Subject: De Beers Snap Lake EA -- March 14, 2003 Addendum to NRCan's Technical Report Submission of February 14, 2003

Non-Technical Summary of Natural Resources Canada's Technical Comments on the De Beers Canada Mining Inc. Snap Lake Diamond Project Environmental Assessment

SNAP LAKE - TECHNICAL REPORT
submitted by
NATURAL RESOURCES CANADA

Figure 1. Mean annual air temperature for Yellowknife from 1943 to 2001 (Data from Environment Canada)

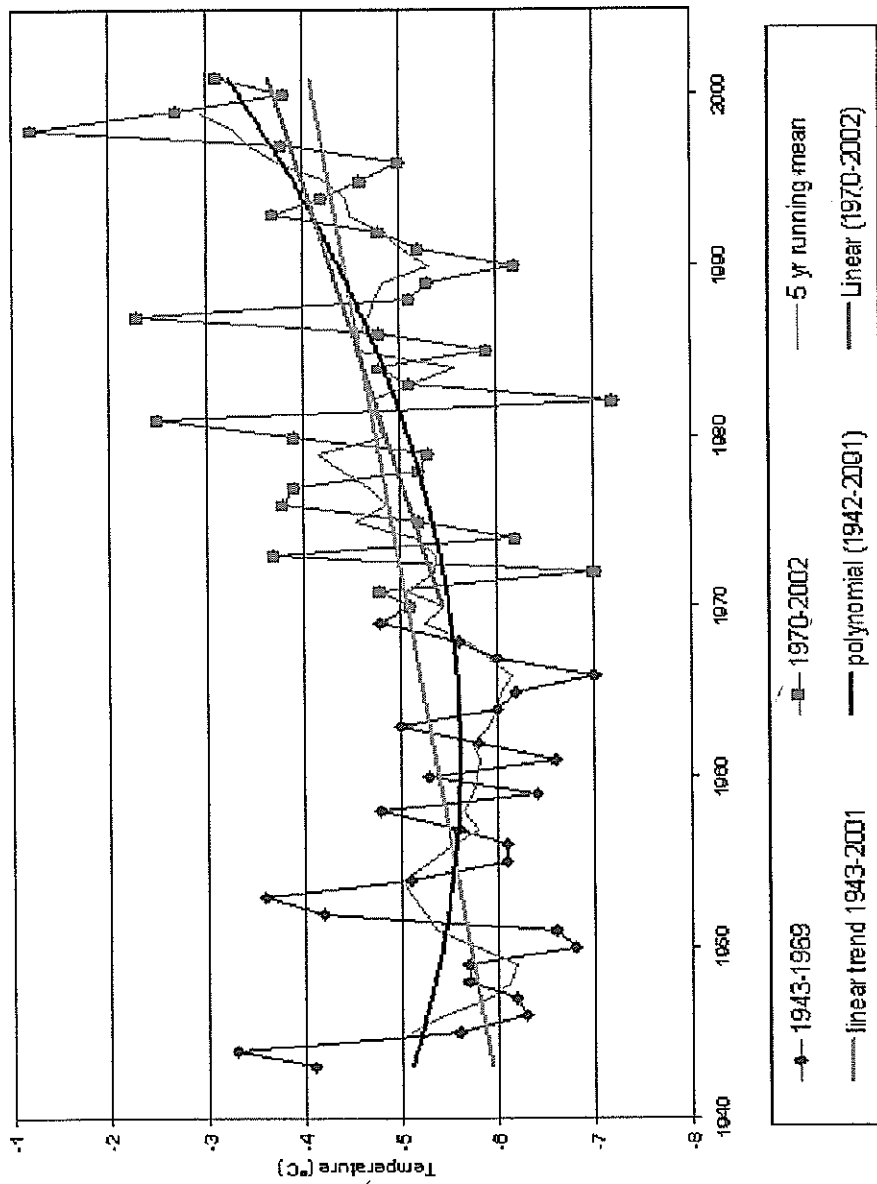
Fitting a straight line trend to a data set that is not inherently linear does not provide the best representation of the change in air temperature over time. Both the records of mean annual air temperature and the mean winter temperature for Yellowknife (Environment Canada data) show a decreasing trend from 1944 to the late 1960s to early 1970s which is then followed by an increasing trend (Figs. 1 and 2). If a low order polynomial is used instead of a linear fit, an increase in the rate of change is also observed from the 1970s to the present. A more appropriate approach would be to break the data set into two sections and determine the linear trend for both or to fit a non linear equation to the entire data set. The proponent's analysis does not consider that there is an increasing trend in air temperature (decreasing trend in air freezing index) over the last 30 years of the record and underestimates the increase in temperature that has occurred over the last 30 years (Figs. 1 and 2). The proponent's analysis therefore probably does not represent current conditions and extrapolation of this trend will likely underestimate air temperatures (or overestimate the freezing index) in future years. This could have important implications for the operating window of the road over the lifetime of the project even if traffic volumes over the last 15 years are reduced from the peak values.

The proponent should at a minimum conduct a trend analysis for the last 20 to 30 years of air temperature data to produce a more conservative estimate of the operational window of the winter road over the life of the project to consider what impact a shorter season may have on the project.
